BCA Assessment Report

4 - 10 Inman Road, Cromer

Reference No: 113390-BCA-r1

Revision	Date	Description		
113390-BCA-r1	23 September 2021	Preliminary BCA Assessment Rep	oort (CC Stage)	
		Prepared by Verified by		
		Josh Harvey	Joshua Harvey	
		Registered Certifier Registered Certifier		
		Grade A1, No. BDC 2460	Grade A1, No. BDC 2417	
		Building Regulations Consultant	Building Regulations Consultant	
		My	W.AL

Figure 1-Additional Egress Door

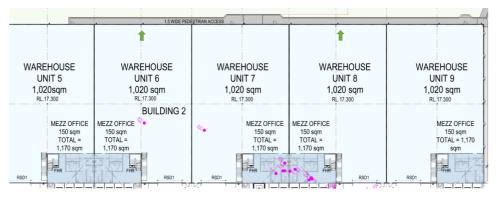
It is recommended than an additional door is provided along the eastern boundary providing access to the pedestrian egress path.

It is important that through the Fire Engineering process consideration is giving to future fit outs or racking plans and worst case scenario is assessed.
